Maelor Foods, Pickhill Lane, Cross Lanes, Wrexham

Variation of Condition 07 of planning permission

APP/H6955/A/18/3216187 (P/2017/1032) to permit the processing of 2,000,000 birds per week

Response to Wrexham Council Highways Comments

Drawing Title	ALTERNATIVE DESIGN RETAINING WALL
---------------	--------------------------------------

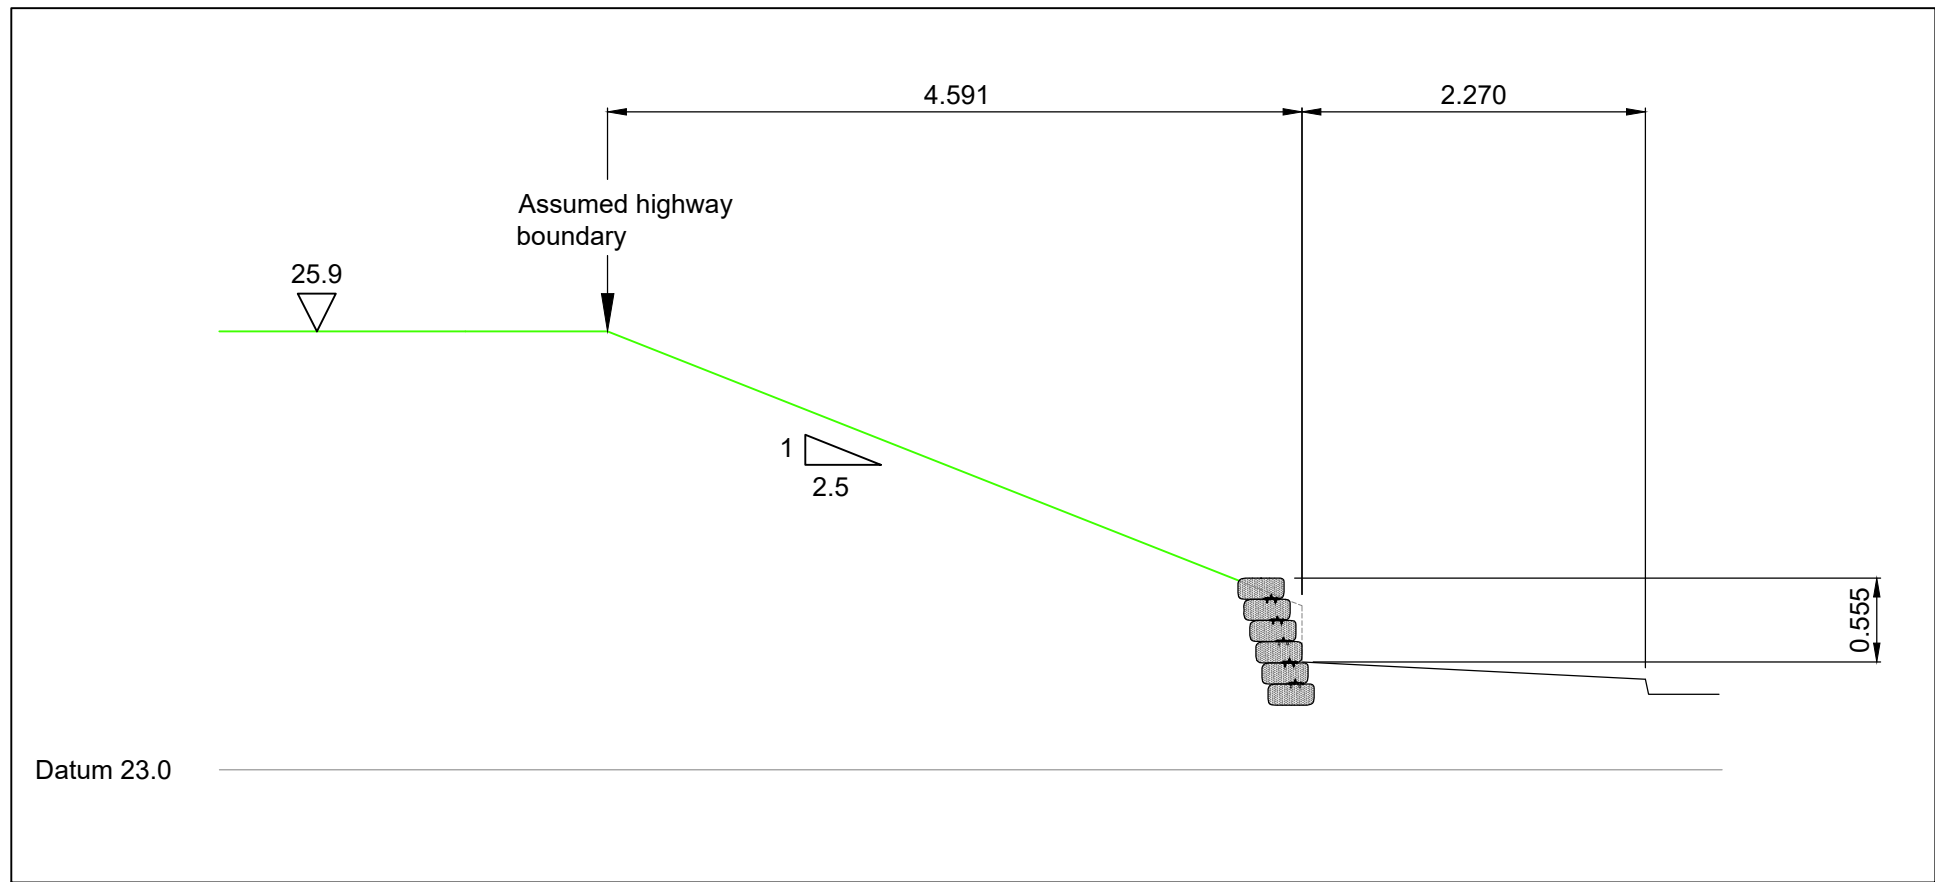
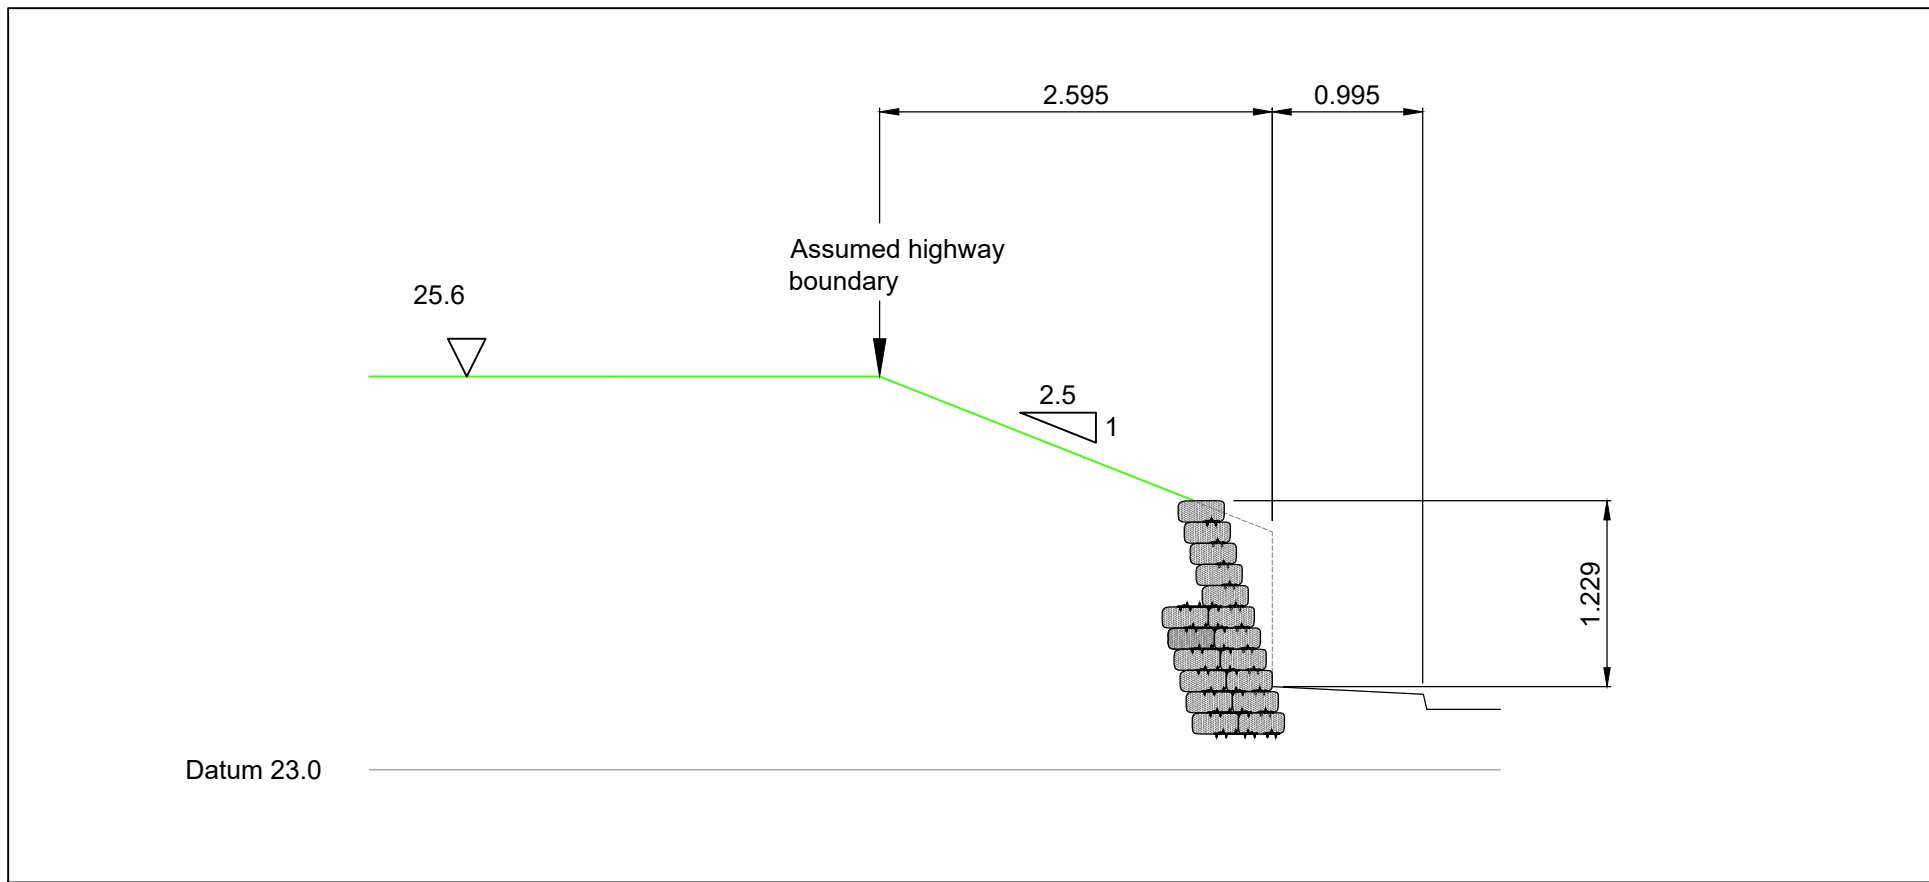
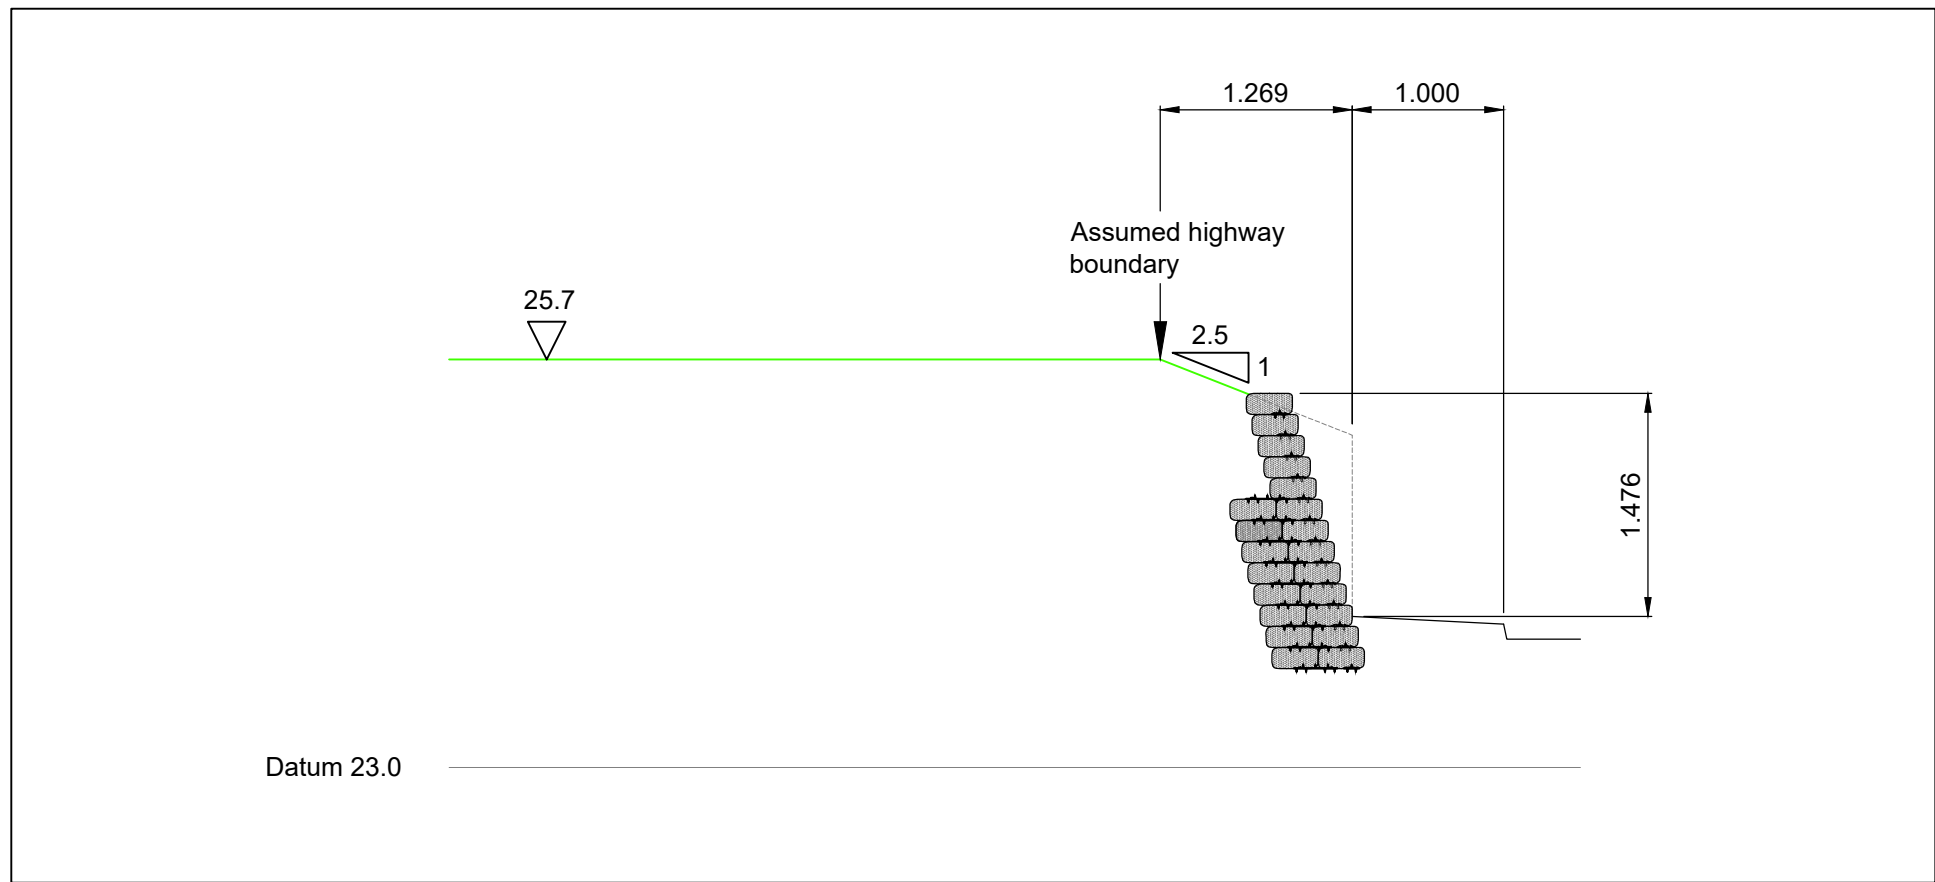
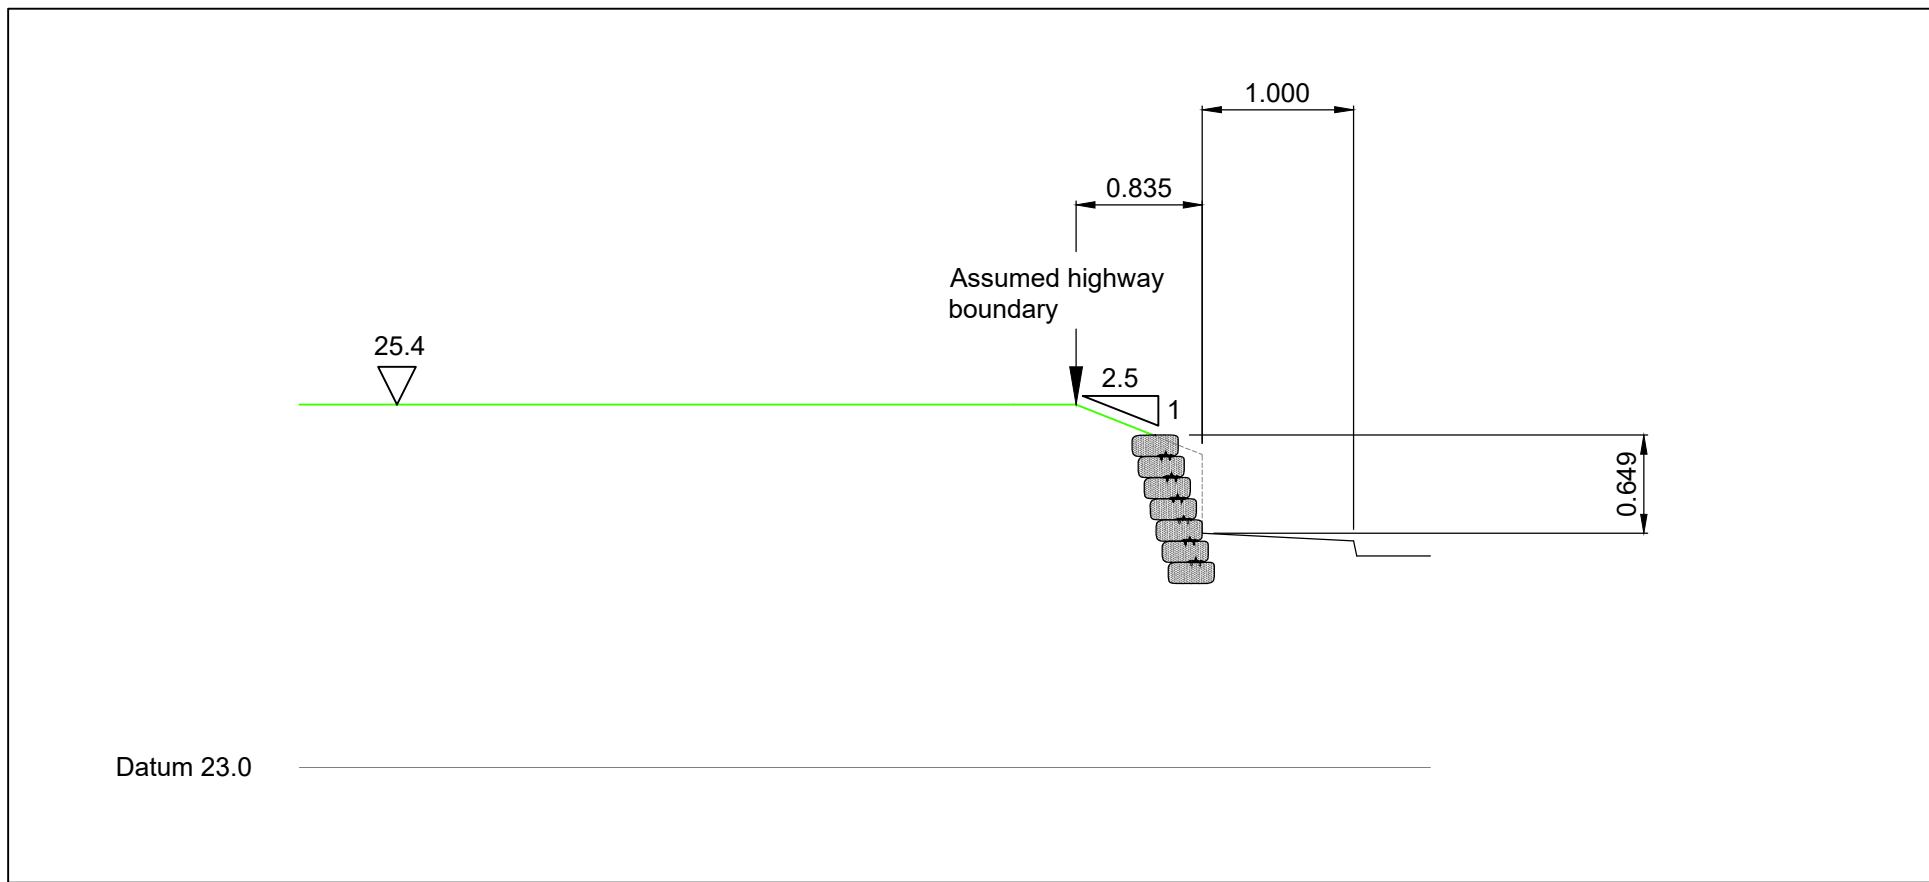
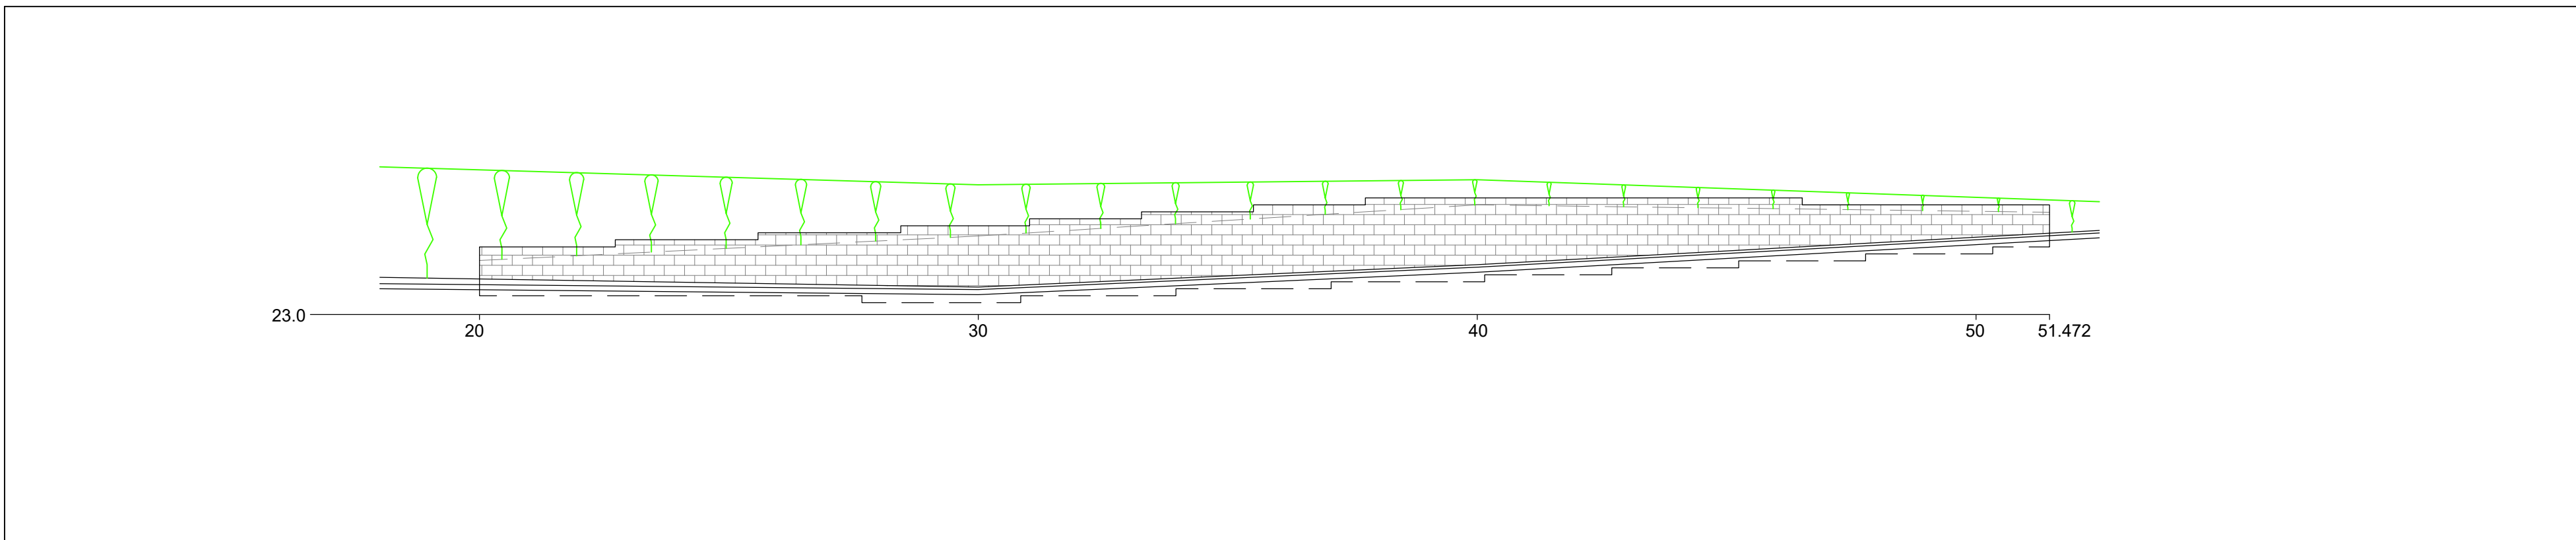
It is noted that the proposals will include a retaining wall on the north-western extents of Pickhill Lane. A detailed plan associated with the retaining wall will also need to be provided and approved by WCBC structures team.

40. A detailed plan has been prepared and is provided as **Appendix D** to the rear of this report. This highlights just one option for the retaining wall (there may be other options as part of further detailed design in due course) with a modular block system over a length of approximately 30m.
41. Sections have been provided at regular intervals along the length of the retaining structure. The maximum height of the structure would be 1.45m with the majority around 1m in height.
